HIGHLAND CITY
HIGHLAND CITY DEVELOPMENT
ADMINISTRATION BOARD AGENDA
Thursday, August 28, 2025

DATE: August 28, 2025
TO: Development Administration Board
FROM: Rob Patterson, City Attorney / Planning & Zoning Administrator
SUBJECT: **Final Plat Approval:** Sloan Estates
TYPE: **LAND USE (ADMINISTRATIVE)**

DATE: August 28, 2025
TO: Development Administration Board
FROM: Rob Patterson, City Attorney / Planning & Zoning Administrator
SUBJECT: **Final Plat Approval:** Inverness - Highland Blvd
TYPE: **LAND USE (ADMINISTRATIVE)**

OVERALL UTILITY PLAN

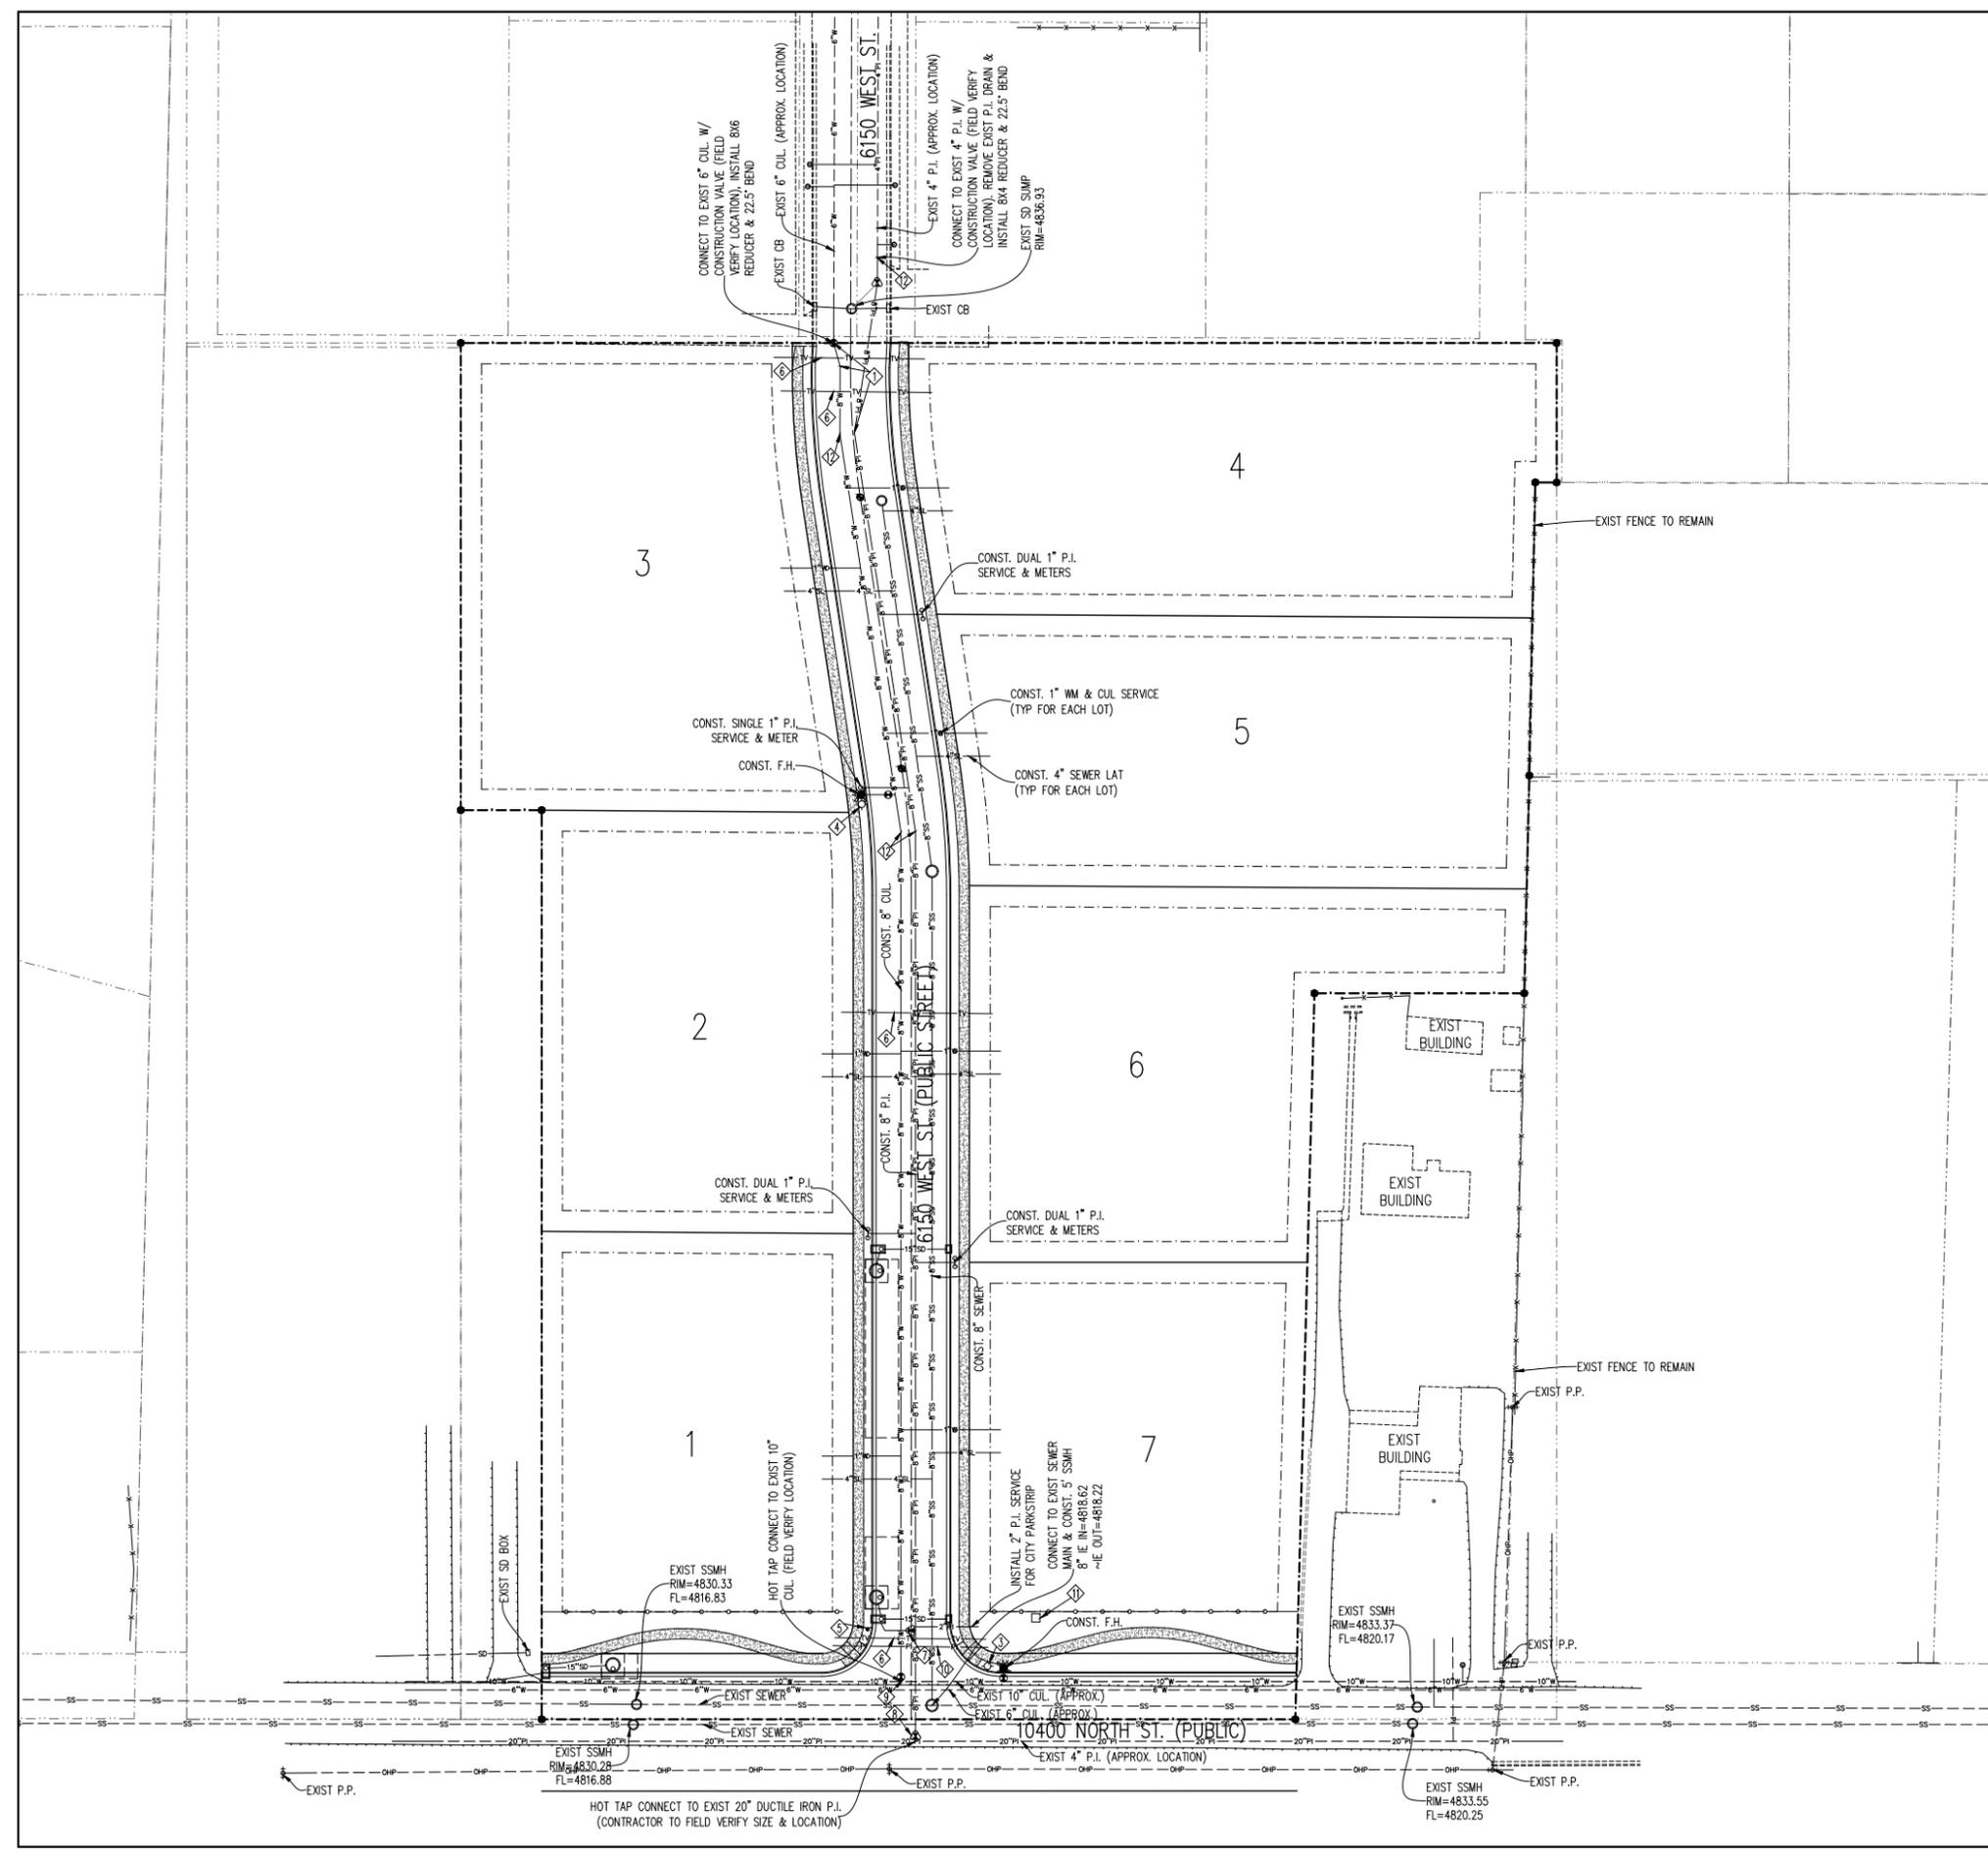
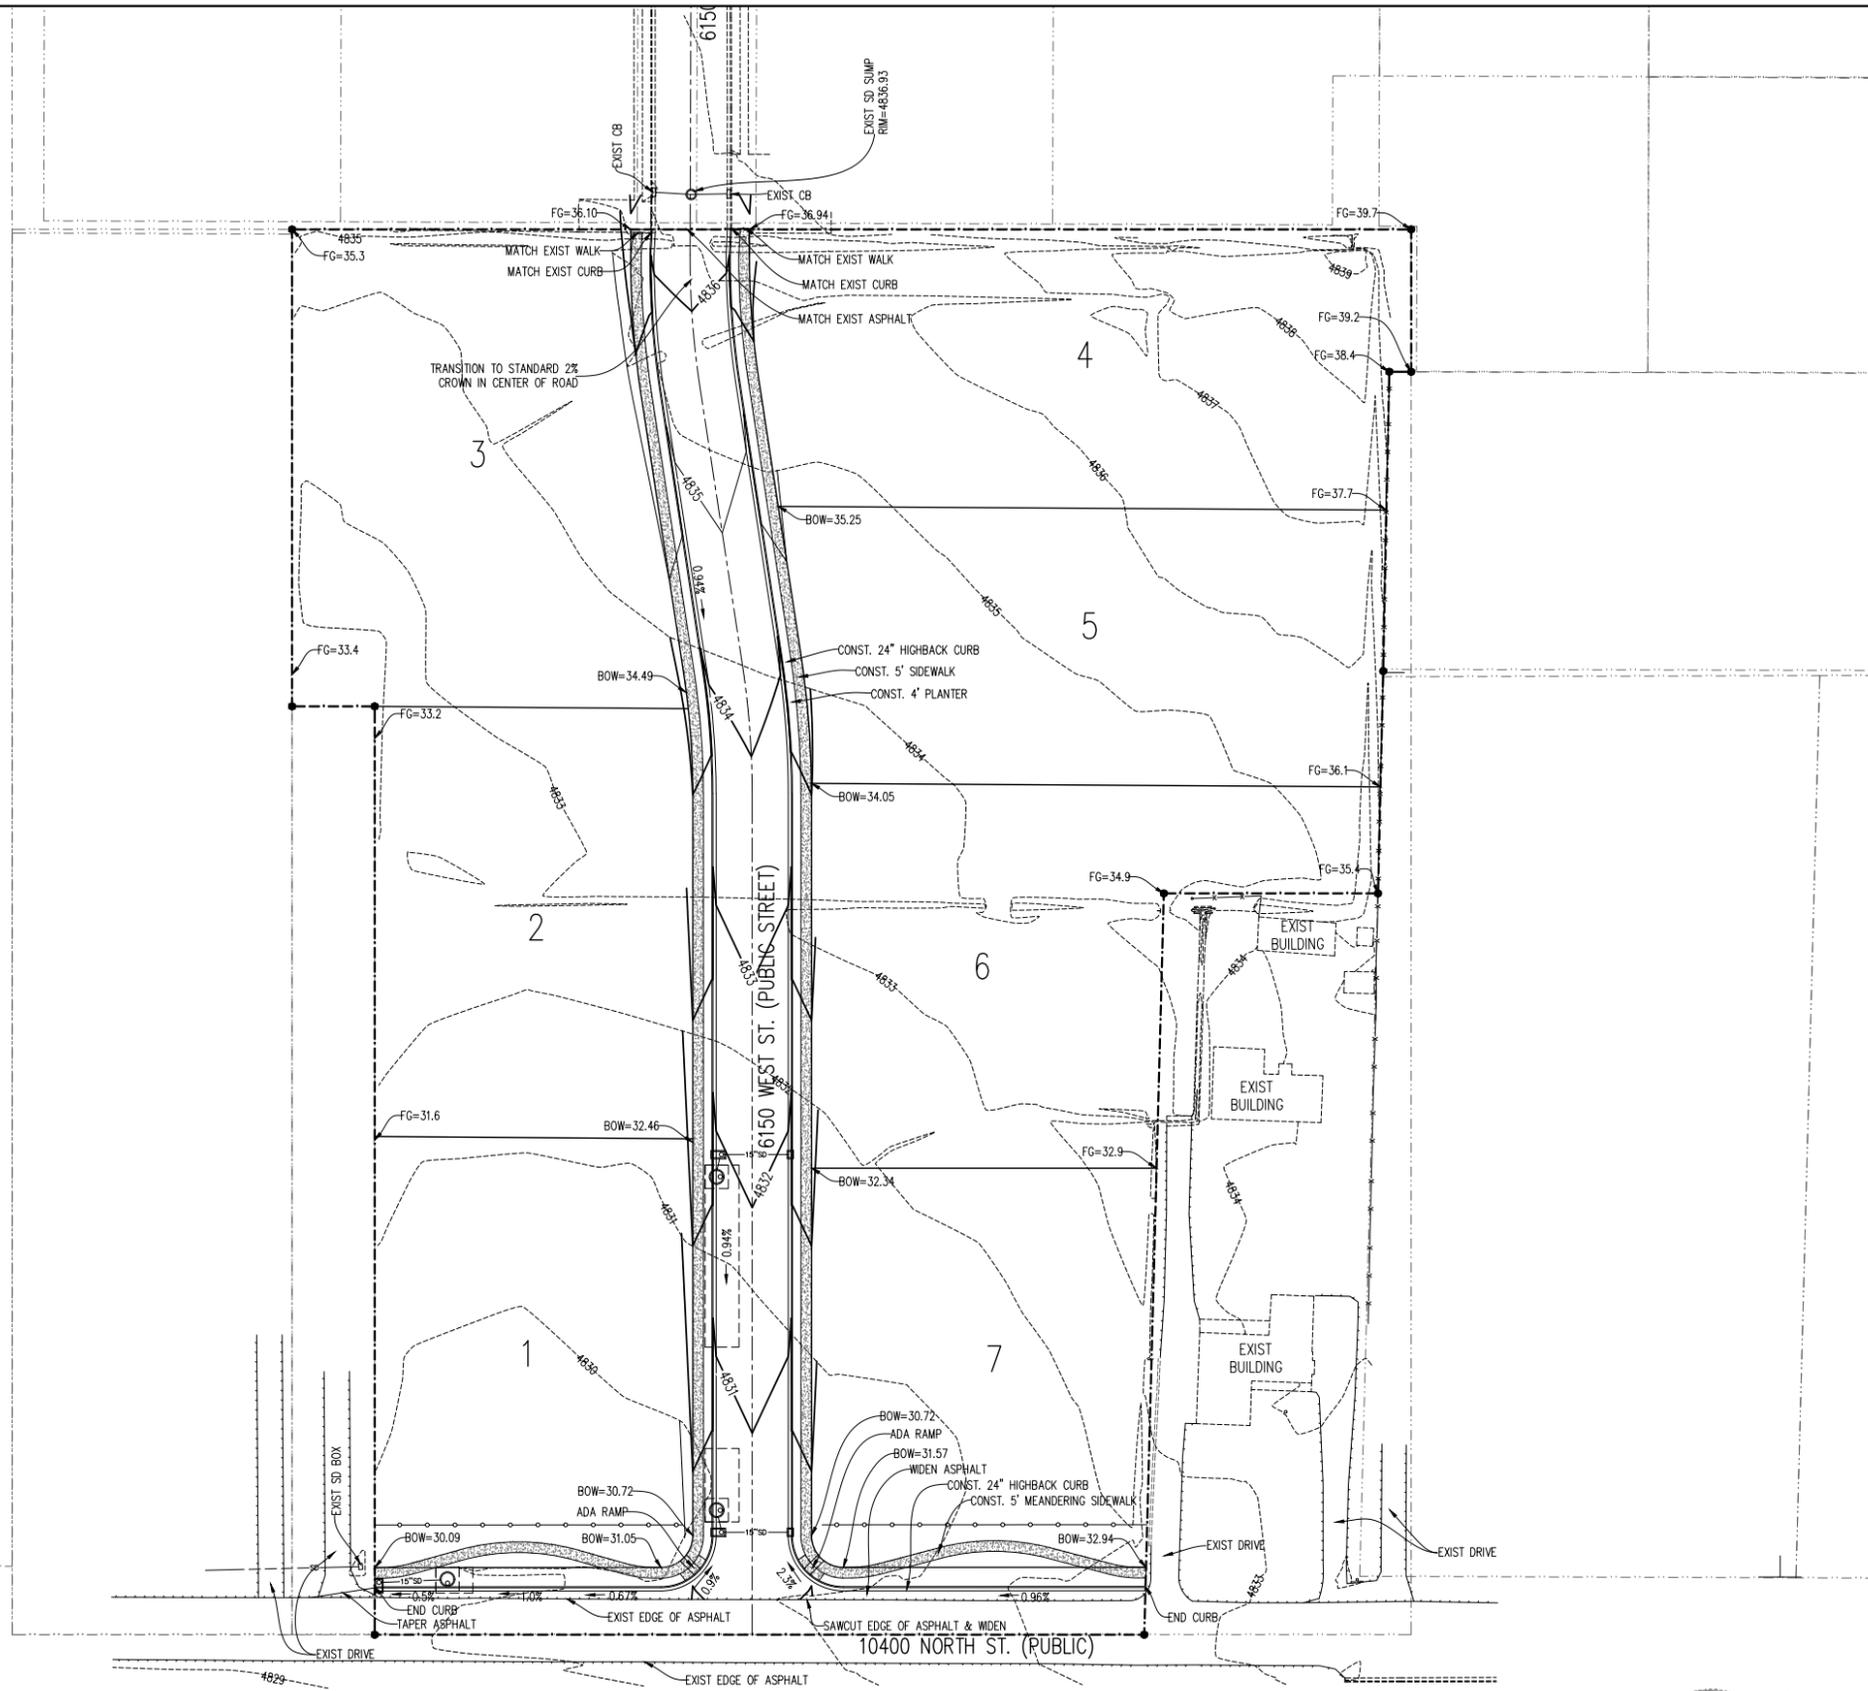
2. A 2" service is needed to provide irrigation water to parkway detail area. A 4" conduit would be needed across 6150 West to make the proper connections with both sides of the street. Reference ST-07 for details.
 - a. Please add a single 4" conduit dedicated to irrigating the other side of the park strip.
 - b. Please add PI trench detail to the detail sheets.
3. The site drainage report mentions an observed percolation rate of 1 minute per inch. The documentation provided from the geotechnical report states 3 minutes per inch. Please review and provide the correct perc rate.
 - a. Please provide a copy of the updated drainage report with final submittal.

6150 WEST PLAN & PROFILE

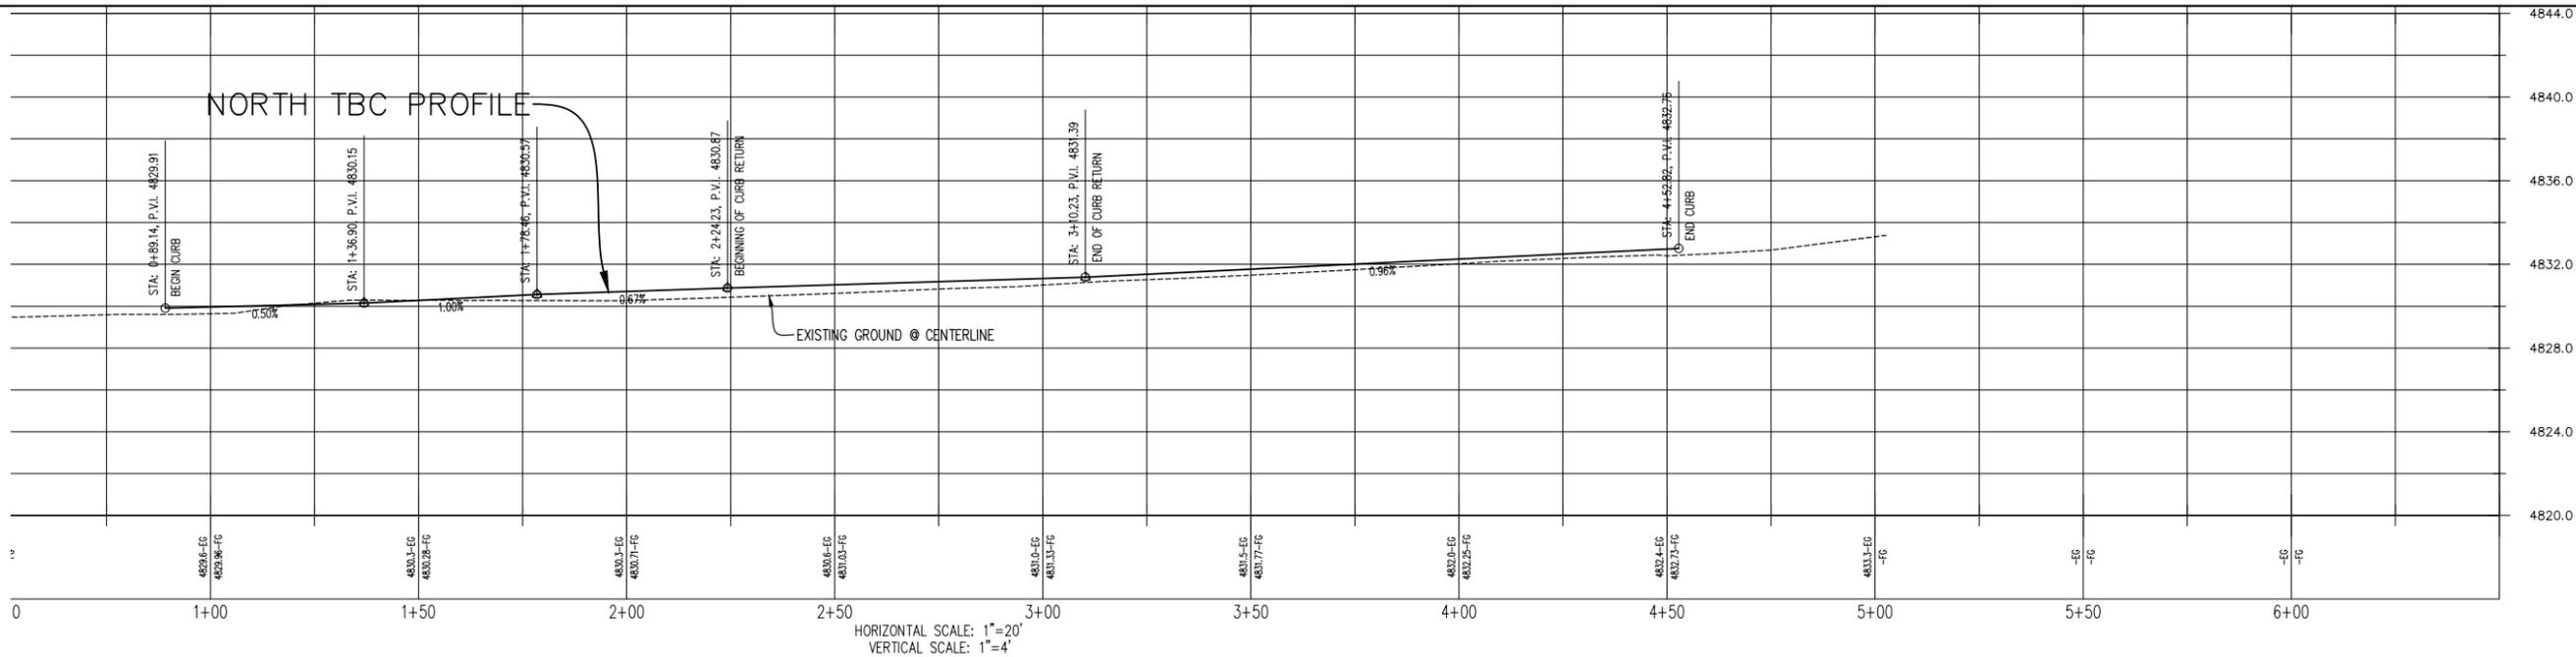
4. 5' SSMH required. Please correct on plan set.
 - a. Please provide callout for both 5'-0 SSMH on sheet U1.
 - b. Also, please correct top-of-line SSMH to be 5'-0 rather than 4'-0.
